HISTORIC AND DESIGN REVIEW COMMISSION

HDRC CASE NO: 2019-557

ADDRESS: 212 COLLEGE ST

TYPE OF WORK: Exterior alterations on the river facade

BEFORE AND PROPOSED N.T.S.

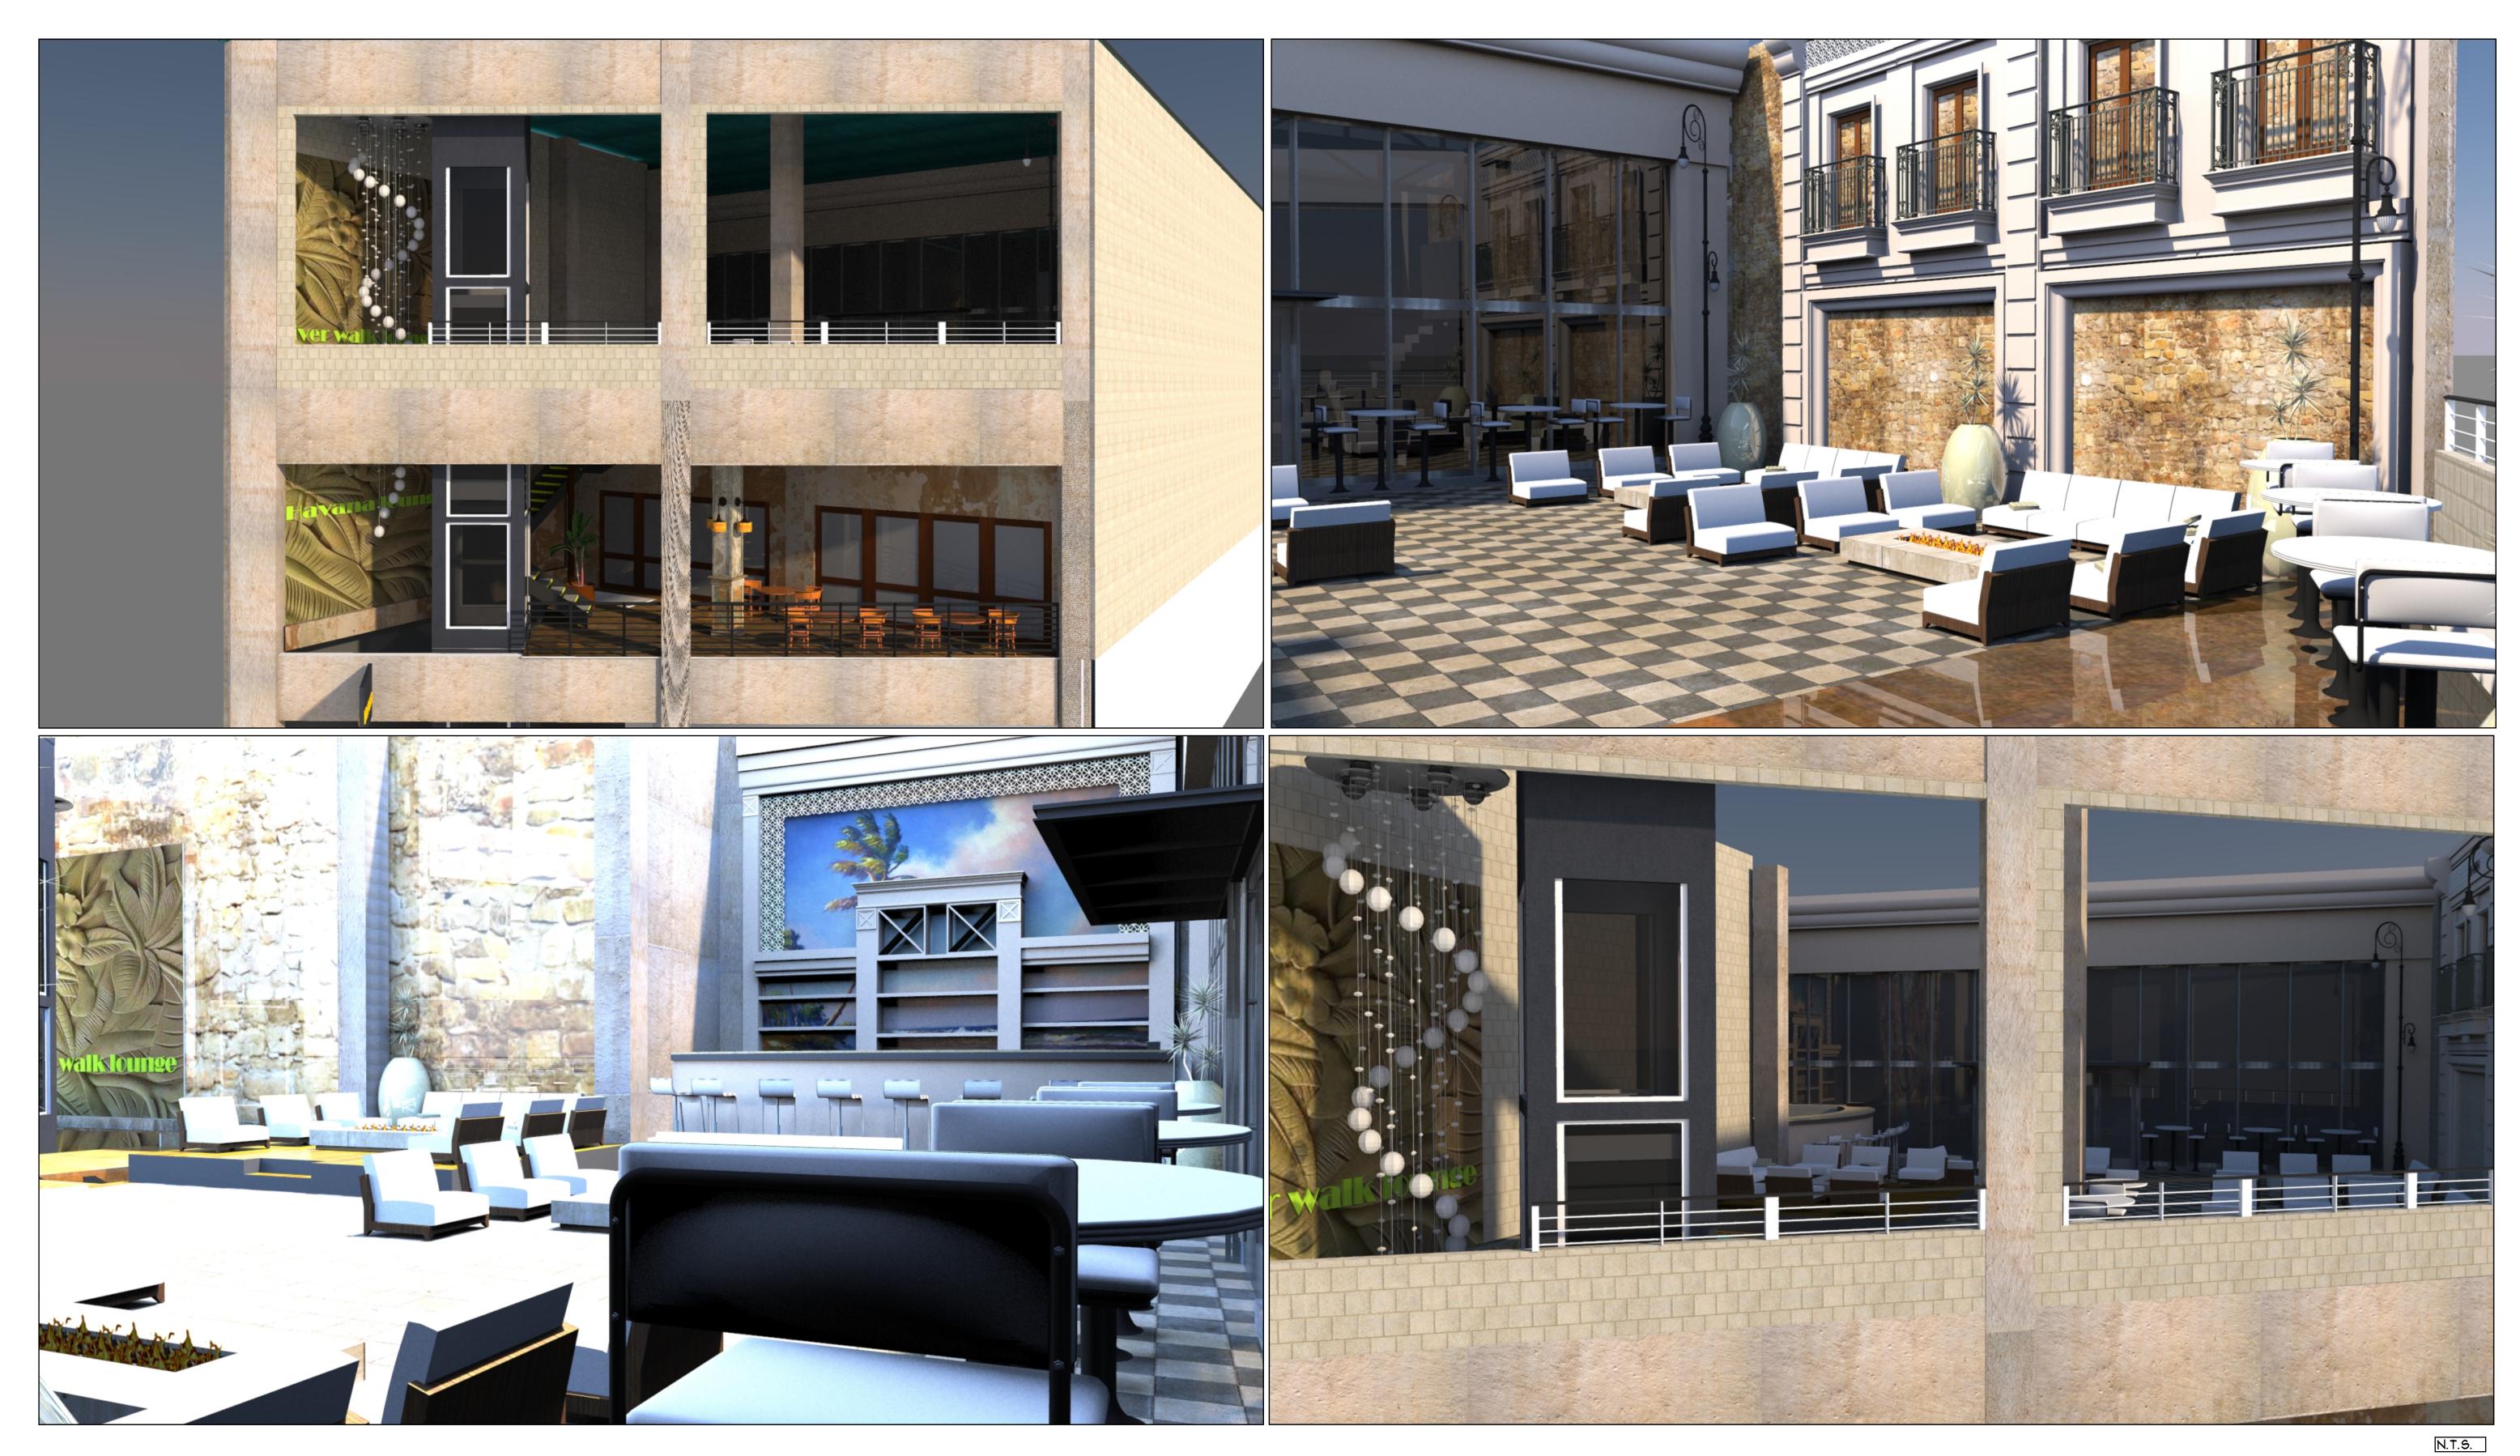
- a. The applicant is requesting a Certificate of Appropriateness for approval to remove the existing, non-original wall of the third floor to create a covered porch. The proposed modification faces the River Walk. The existing façade features masonry materials that are not original to the historic structure.
- b. The applicant has proposed for the open air porch to not feature fenestration or profiled architectural elements on the river facing façade, with the exception of a short railing. Staff finds the proposed modification to be appropriate.

Staff recommends approval based on findings a and b with the stipulation that the applicant attempt to salvage any removed masonry material. Removed materials do not need to be salvaged on site.
